**General Steel Industries (GSI) SEC-00105 Co-Petitioner
Dan McKeel's Critique of Appendix BB Rev 1 (6/6/14)**

Daniel W. McKeel, Jr., M.D.
(© July 2014 - version 1.5, 7.15.14)

This document is a scientific critique of Appendix BB Rev 1 (hereafter abbreviated "AppBBr1") dated 6/6/14 by David Allen of DCAS/NIOSH. SEC Counselor Josh Kinman e-mailed the PA-cleared version to Dan McKeel on June 25, 2014. Mr. Kinman noted he had sent a copy to "one other" person (not named). Presumably this person was the primary GSI SEC-00105 petitioner, Patricia (formerly Coggins) Jeske. As of this date, Mrs. Jeske has not confirmed receipt to McKeel of receiving a copy of AppBBr1.

Figure 1 – Drawing of the Old Betatron Building
Drawing of the old betatron building from FUSRAP documentation
(See following page)

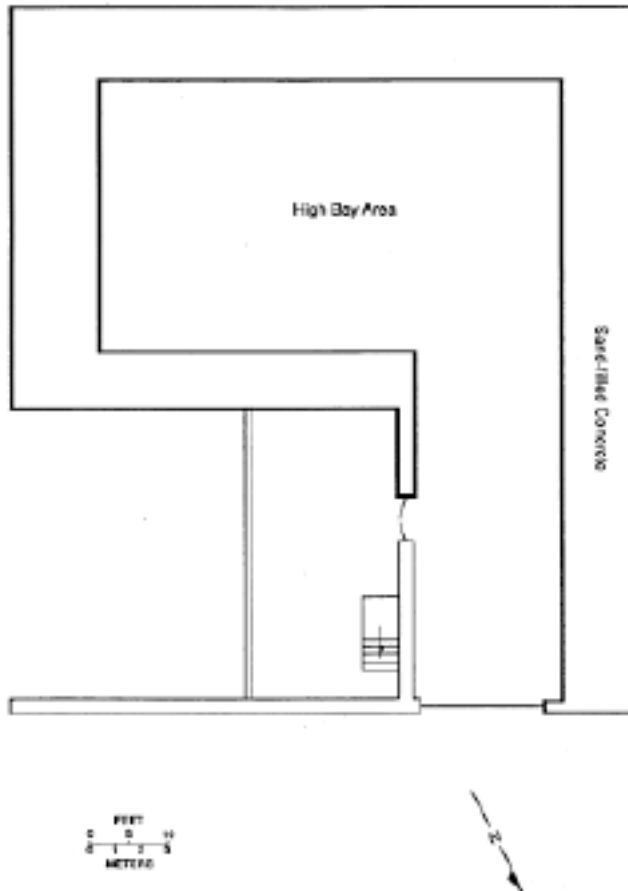
[7. *Figures 1 and 2 provide drawings*] -- Actually, Figures 1 through 5 inclusive provide GSI Old and New Betatron building drawings. Allen omits the source documents for these cartoon sketches. They were not drawn based on any extant blueprints. To the knowledge of the GSI expert team, NIOSH made no effort to obtain Old Betatron building blueprints or purchase orders or construction permits or, in fact, any records about the Old Betatron Building and installation from USACE. The agency should have made this effort; that is part of their job. The quality of reproduction of these figures is poor and better drawing copies should be substituted. Some of the lines and labels are indistinct. In all cases, exact citations should be given as to the reference source documents for each of the Old and New Betatron building drawings used in AppBBr1, which is, after all, a scientific technical document. The various Betatron building sketches were done at different time points and they vary in significant ways that need to be pointed out explicitly (as has been done by the SINEW expert team) by Mr. Allen and DCAS/NIOSH.

MCKEEL COMMENT on Figure 1. This drawing above appears to be an MCNP construct rather than a FUSRAP drawing. Allen needs to provide more exact reference to a specific FUSRAP report title, number and page to refute this interpretation.

Figure 3 – New Betatron Building Drawing with Dimensions

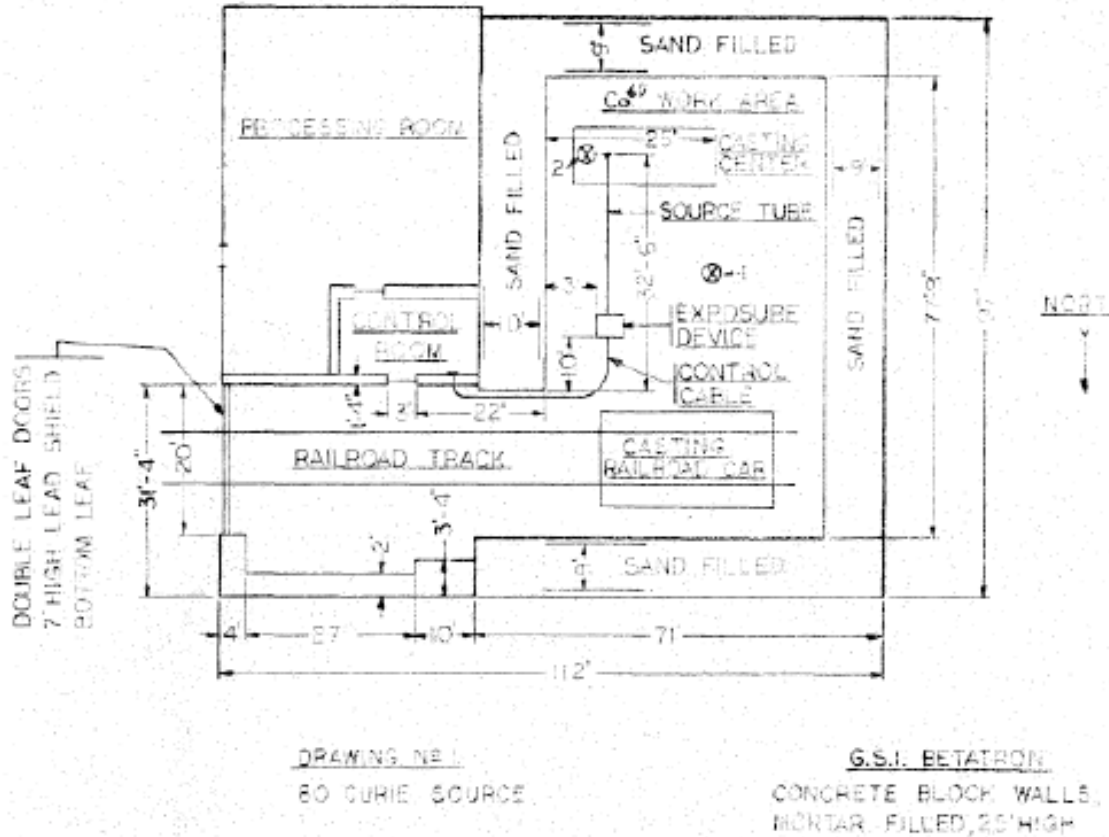
MCKEEL COMMENT ON FIGURE 3 -- A clearer copy of this drawing needs to be substituted. The lines and text are faded and are difficult/impossible to read. The quality is unacceptable for an important scientific publication.

Figure 4 – Drawing of New Betatron Building with Nearby Buildings

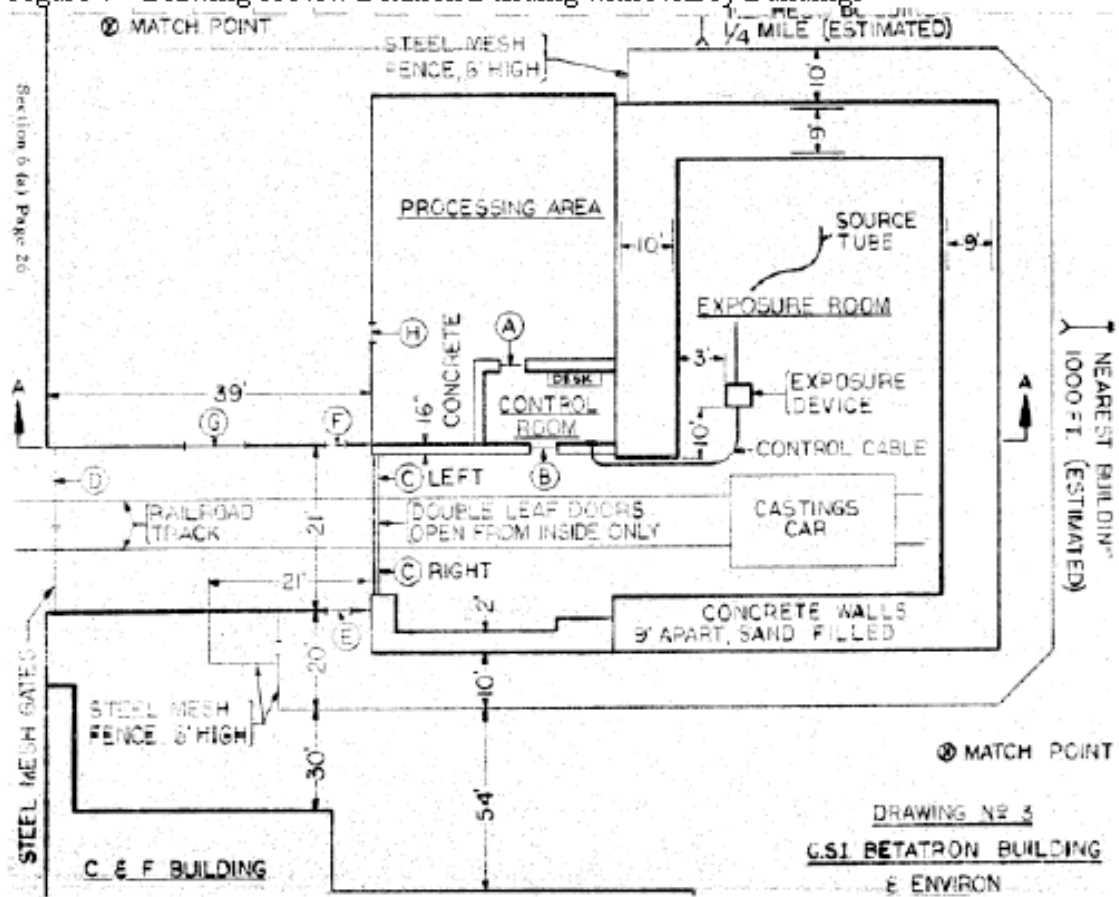
MCKEEL COMMENT ON FIGURES 4 and 5 -- Clearer copies of these drawings need to be substituted. The lines and text are faded, text is difficult or impossible to read. The quality is unacceptable for a scientific publication.

Figure 8 – Radiography Room in #6 Building

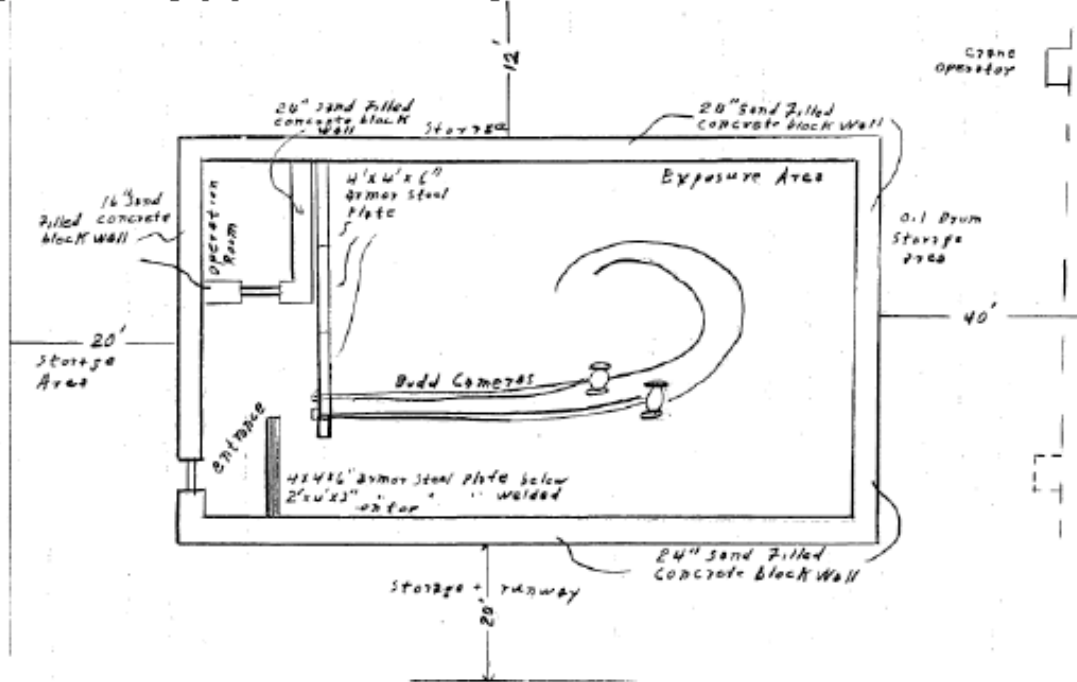
[2. A special radiography room was built within the #6 building] -- Allen needs to note the structure was built in 1955 (two eyewitnesses) and at first had walls only 8 inches thick composed of perforated 8 inch concrete blocks. A GSI 1957 master engineering drawing clearly showed an inner "radiography room" within the confines of Bldg. 6 (from a McKeel white paper).

[11. *it was reported that the majority of radiography occurred in the radiography room of the number 6 building*] -- (a) It is tedious to have to state that once again Allen has ignored the affidavits of two GSI workers (Dave Woodard and Danial Churovich), who both were eye witnesses to the inner concrete block "radiography room" marked on the GSI 1957 master engineering drawing that the GSI site expert team provided to the TBD-6000 WG and documented in McKeel white papers. Both GSI workers stated the inner, roofless building 6 radiography facility was constructed in the year 1955 and had 8 inch thick concrete block walls filled with "Miss. River sand."

[12. *drawing from the AEC license application (figure 8).*] -- The cited document

ATTACHMENT A – Dose Estimate for Walking Through Radiography Area

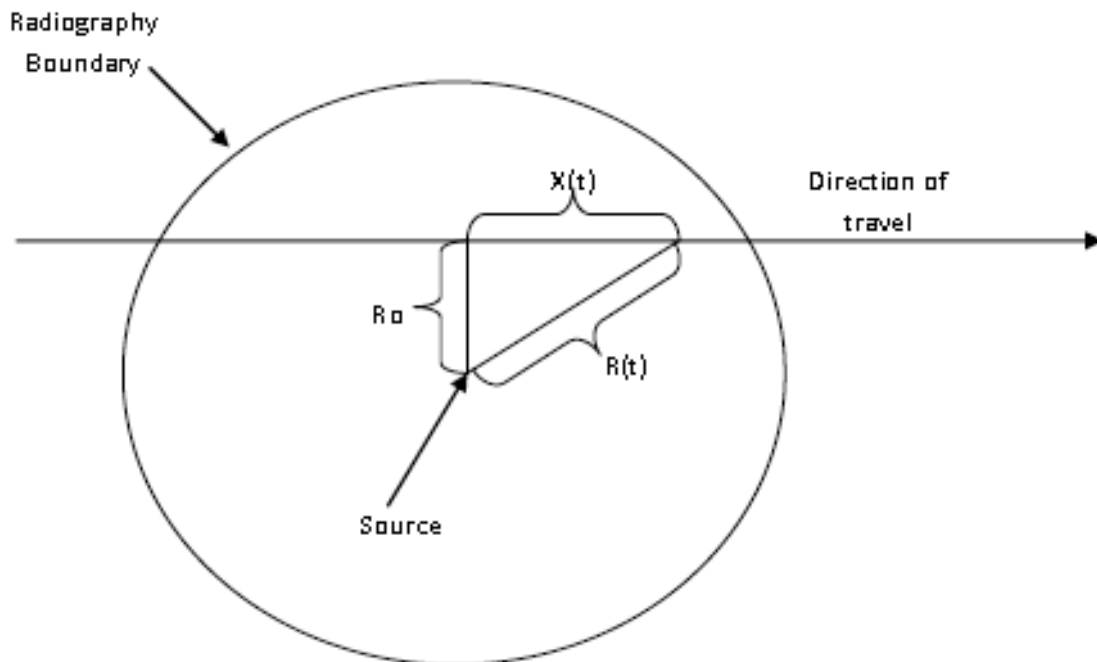
MCKEEL COMMENT to Attachment A: The phrase at issue is: “delineated

Figure B.1 – Average Airborne Activity while Handling Cold Metal (dpm/m³)

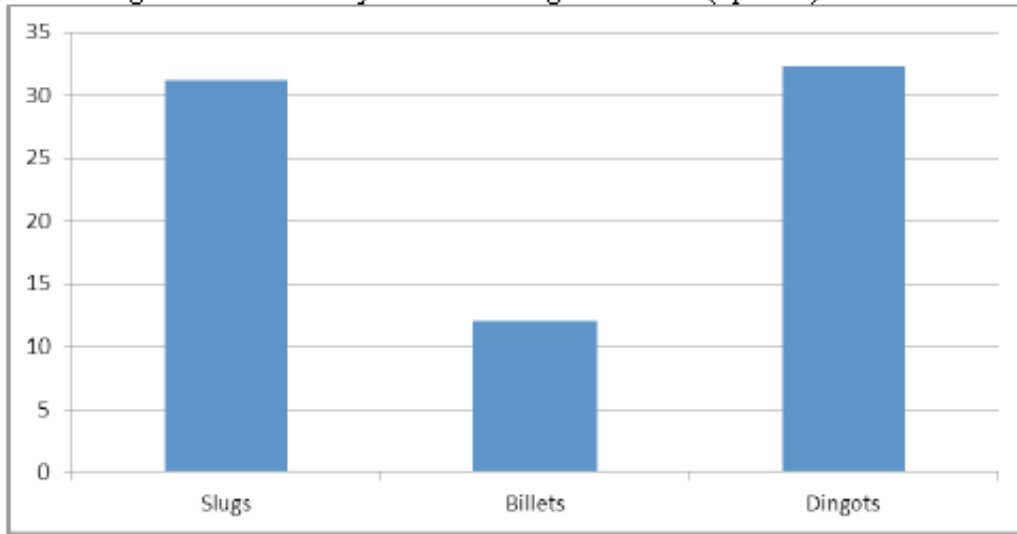
MCKEEL COMMENT TO ATTACHMENT B: These data were the subject of extensive discussion at TBD-6000 WG meetings. Once again, AppBBr1 ignores McKeel's main objections to the use of this specific surrogate data: (a) GSI did not work with uranium slugs, hence the slug facilities are *per se* not similar and thus do not meet Board surrogate data criteria; (b) much higher air concentrations of uranium were documented in Adley 1952 (Hanford melt

plant) among the crews that unloaded railroad cars. The airborne concentrations were so high that some workers had to be placed on short shifts to avoid exceeding permissible uranium intake exposure limits. Mr. Allen ignores these discussions and McKeel's white paper on the Adley 1952.
